**TOWN OF ERIE
BOARD OF TRUSTEES MEETING
May 28, 2019**

SUBJECT: **Agenda # 19-252**

Review of the Canyon Creek Filing No. 7 & 8 Sketch Plan

PURPOSE: Review and comment on a Sketch Plan application for 109 single-family lots and 88 duplex lots.

Below, with the site outlined in a red dashed line, is the Future Land Use Plan Map from the Comprehensive Plan:

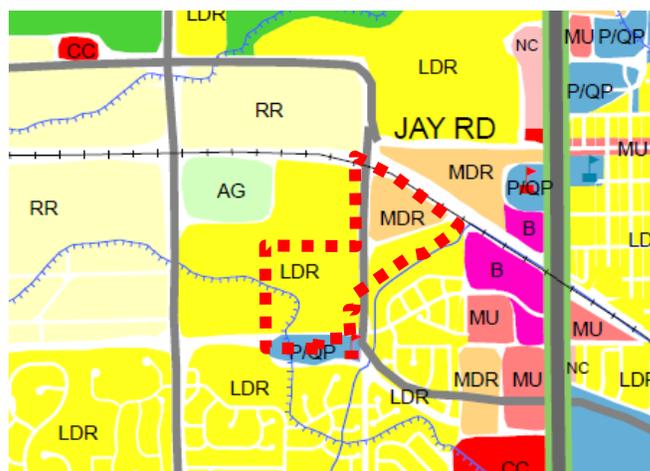
The majority of the property is designated as LDR – Low Density Residential (2-6 du/ac) on the Comprehensive Plan, Land Use Plan Map. An area of Filing 8 is also designated as MDR – Medium Density Residential (6-12 du/ac). LDR areas will primarily be suburban-style developments; however, the designation allows for a range of single-family detached and attached homes, townhomes, patio homes, and in appropriate cases include complementary neighborhood-scale supporting land uses, such as retail, commercial, and office uses in a neighborhood setting. MDR areas should incorporate a mix of housing types and recognizable community centers such as park, recreation, and neighborhood or community commercial areas in a neighborhood setting. The submitted Sketch Plan meets the intent of LDR and MDR per the characteristics, as the Sketch Plan proposes developing the site as single-family residential in Filing 7 (2.92 du/ac) and duplex residential in Filing 8 (6 du/ac).
